AP 108F-0904-12

OXYGEN HOSE ASSEMBLIES

GENERAL AND TECHNICAL INFORMATION

GENERAL ORDERS AND MODIFICATIONS

Fig 3 Oxygen mask hose assembly Mk 9A
(Mod PE58 incorporated)

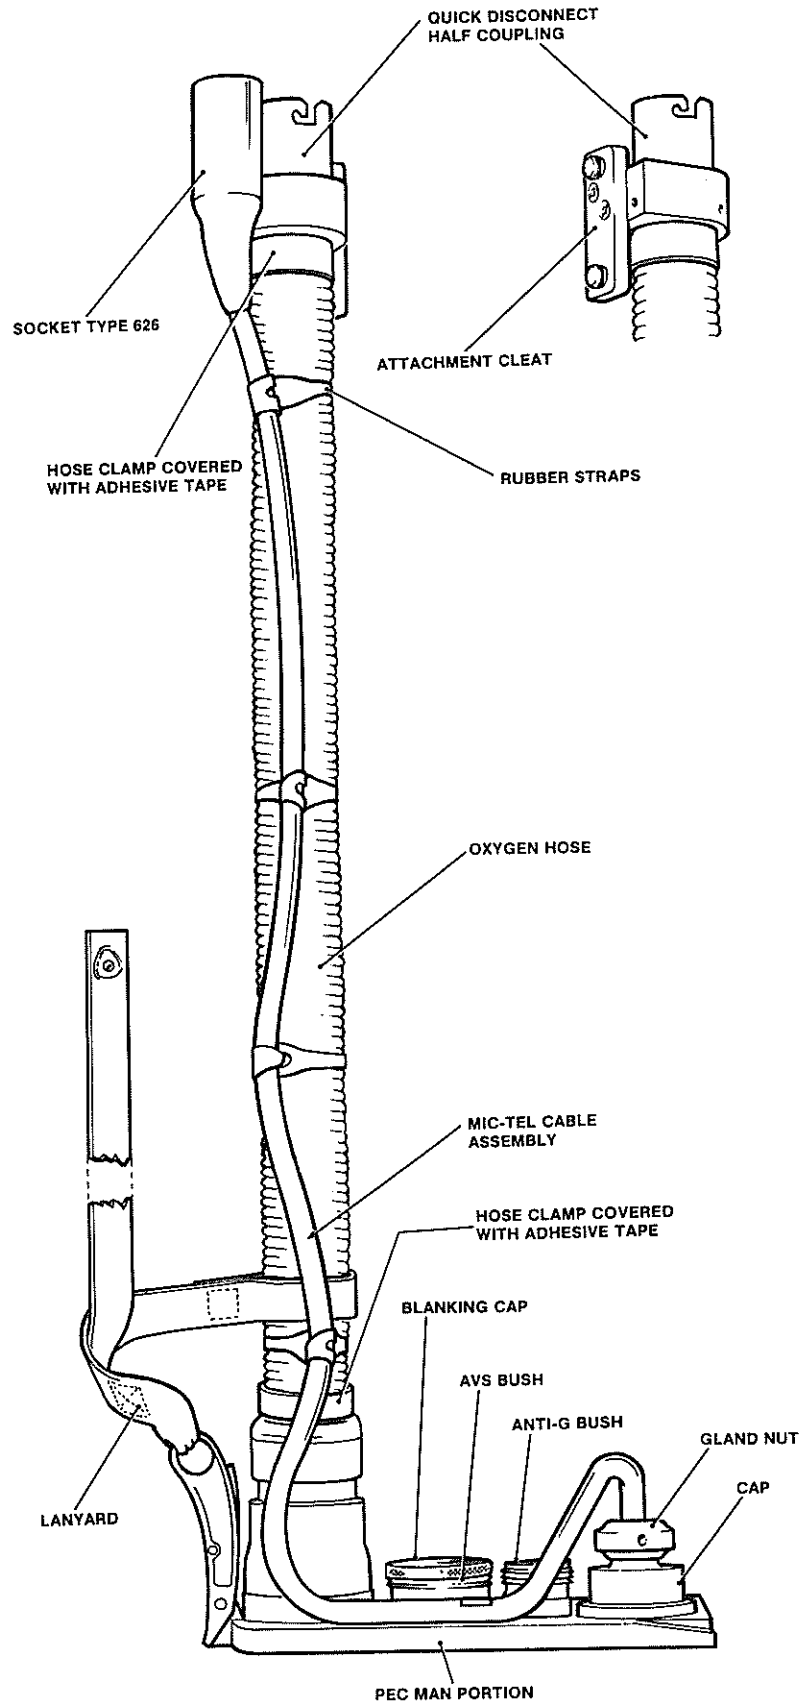
► OXYGEN MASK HOSE ASSEMBLY Mk 9A (Fig 3) (Mod PE 58 incorporated) ◀

Fig 1 Oxygen mask hose assembly Mk 11

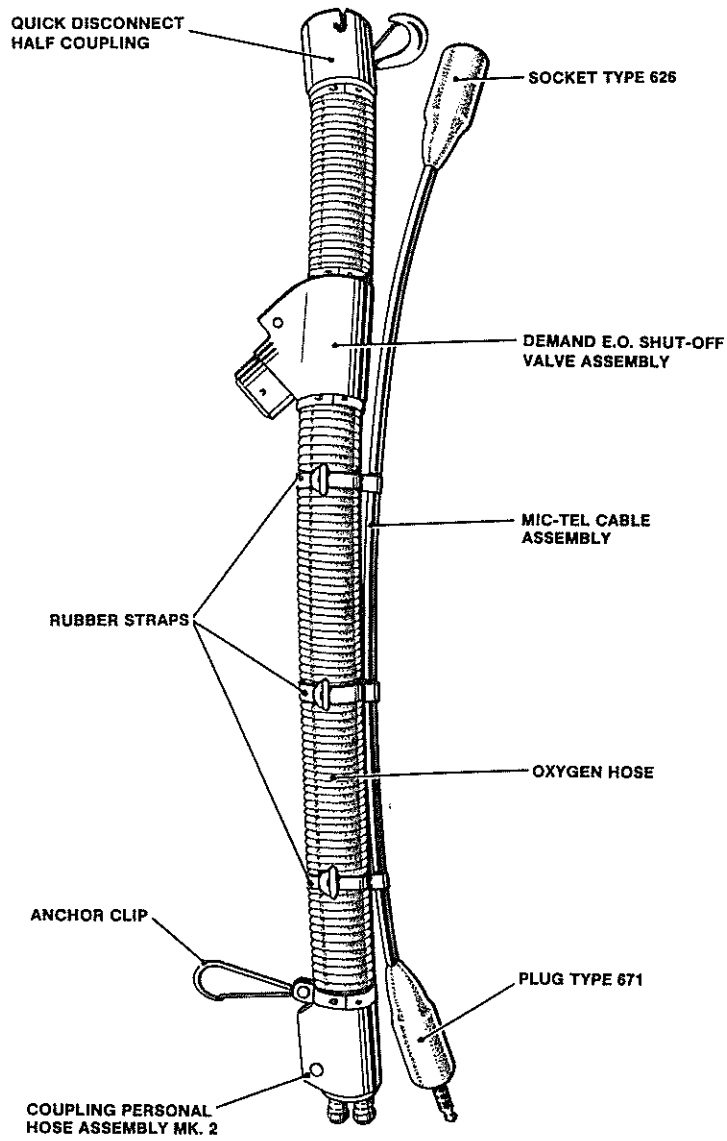
1 The oxygen mask hose assembly Mk 11 is a low altitude assembly used by rear crew members of Vulcan and Victor aircraft. It is designed to replace the oxygen mask hose assembly Mk 7 by the embodiment of Modification MX 98 which introduced the personal hose assembly coupling Mk 2 in lieu of the quick release oxygen connector. The assembly permits high altitude bail-out without loss of the pressure breathing facility from the emergency oxygen system.

Drawing No AP 108F-0904-2/8/81 is incorporated in this leaflet.

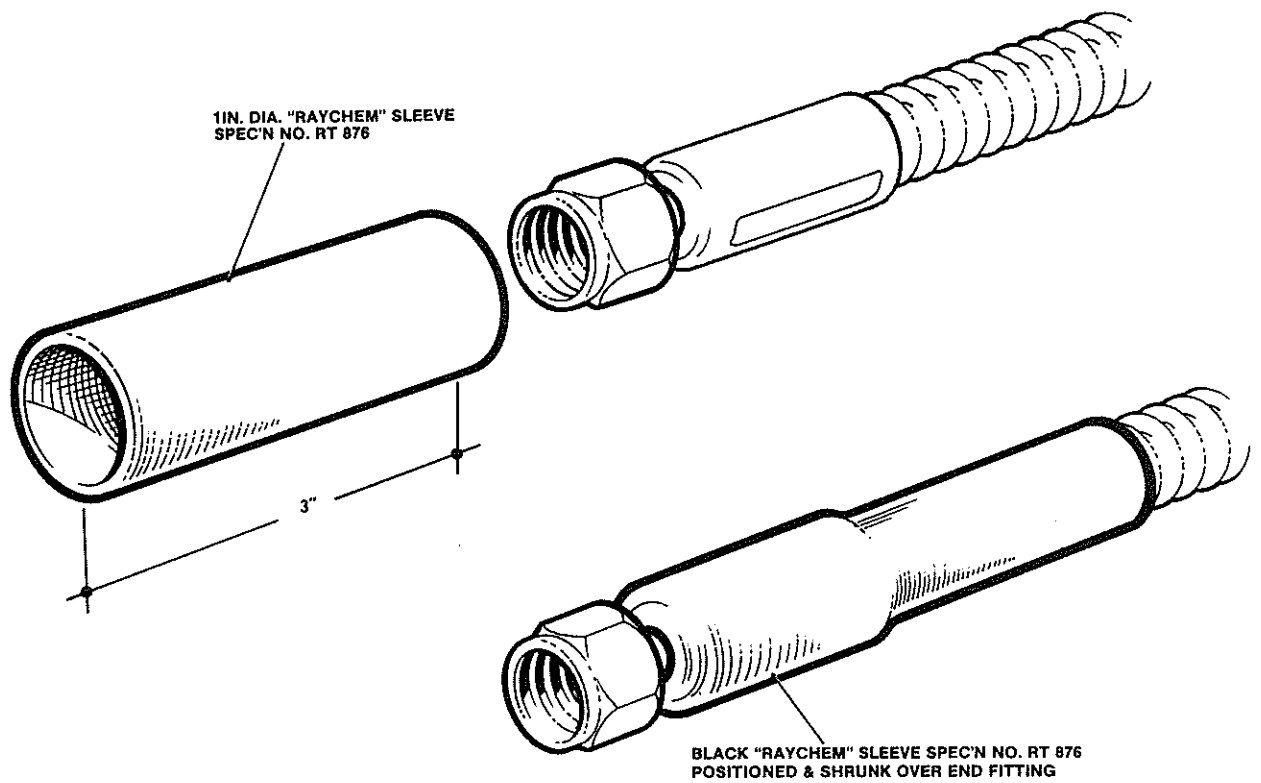
Tests carried out by the Contractor showed that apart from redesigning or re-positioning the various fittings involved, the simplest way to overcome the defect was to provide some additional means of protection to the affected area of the oxygen hose.

This modification is a Contractor's Design Change which precludes the possible defect on those seats in the British Services by introducing heat shrink tubing to the affected areas of the oxygen hose.

- (1) From the oxygen hose assembly, identify and remove the oxygen hose, Part No MBEU 34361 by undoing its connecting nut.
- (2) Refer to the drawing, and position the two pieces of sleeving, Specn No RT876, one over each end of the oxygen hose, Part No MBEU 34361 as shown. Using the Model 1511 "Raychem" Thermogun and Reflector, Part No PR24, shrink the sleeving in position. The oxygen hose now becomes Part No MBEU 56741.

- (3) Re-connect the modified oxygen hose, Part No MBEU 56741 to the oxygen hose assembly.

Drawing No AP 108F-0904-2 (2nd Edn)/9/83 is incorporated in this leaflet.

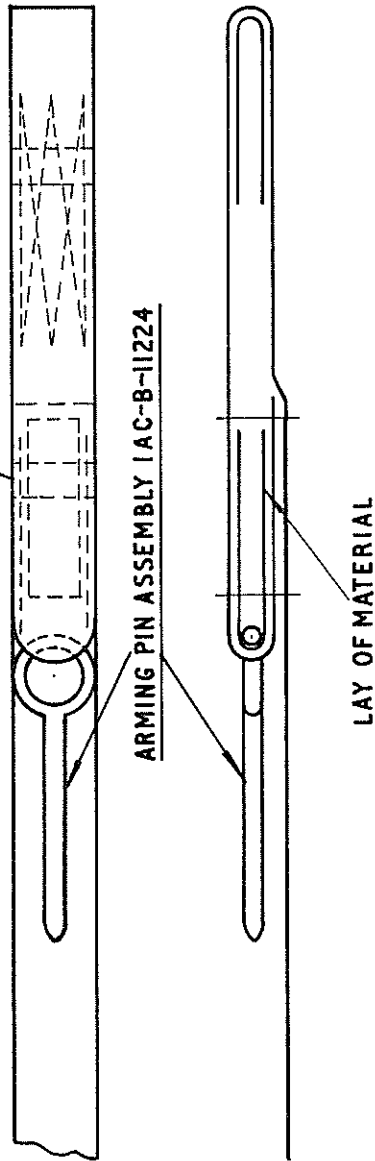
This modification is a design improvement resulting from service experience. Incidents have been reported wherein the soldered arming pin wire attachments have cracked whilst in service use. This modification introduces a solid one piece welded pin which is completely interchangeable with the existing pin in all respects.

- 1 - CUT CAREFULLY & UNPICK STITCHING, SECURING THE ARMING PIN IAC-3372 TO THE STATIC LINE
- 2 - REMOVE THE ARMING PIN IAC-3372
- 3 - POSITION THE ARMING PIN ASSEMBLY IAC-B-11224. MAKE GOOD THE STITCHING UNPICKED TO REMOVE THE ORIGINAL PIN USING THREAD NYLON BS120/NT6/5a; BLUE/GREY
